### Natural & Built Environment Team

Consultation Response

Application No:	P/24/0258/2	
Address:	Brand Hill House, Brand Hill, Woodhouse Eaves, Leicestershire, LE12 8SX	
Description:	Installation of track and use of existing vehicular access point and the track for access to existing dwellinghouse with associated works (Retrospective)	
Comment on:	Built Heritage	
Officer:	Penny McKnight	Date: 2/10/24

### **Revised Plans**

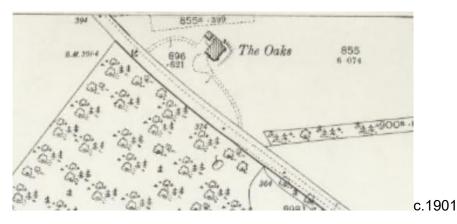
Further to comments dated 26/6/24, revised plans were submitted on 15 August 2024, and more detailed comments have been requested.

- 1. A 'Curtilage Plan' has been submitted confirming a mixed use of 'residential, forestry and for access to the paddock' for the first 25m of the track from the road to the new additional section of track for residential access. The plan also confirms that there is no proposal to extend the residential curtilage to include the paddock or the land around the track.
- 2. A Landscaping Plan has been prepared and the Site Plan has been amended. This shows the blocking up of the existing roadside residential access adjacent to the gates to the paddock, and some supplementary planting.

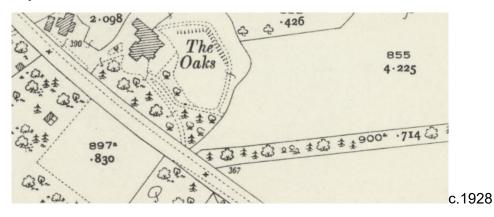
*Removal of existing gate:* The existing metal gate is considered to be a feature that contributes to the special character and appearance of the Woodhouse Eaves Conservation Area (WECA). It appears to date from the late 19<sup>th</sup> century when the grounds to Brand Hill House (then Oak House) were first laid out, and is of decorative cast iron in an Arts and Crafts style. It is paired with the residential access gate further to the northwest, which still serves the drive to the house. The removal of this feature from the street scene of the WECA would harm its character and appearance, and there would be a dilution of the legibility of the historic plan form of the gardens to Brand Hill House.

The removal of the associated driveway would be an unwelcome alteration to the historic plan form of the gardens of Brand Hill, but in isolation would not be considered to harm the character or appearance of the WECA
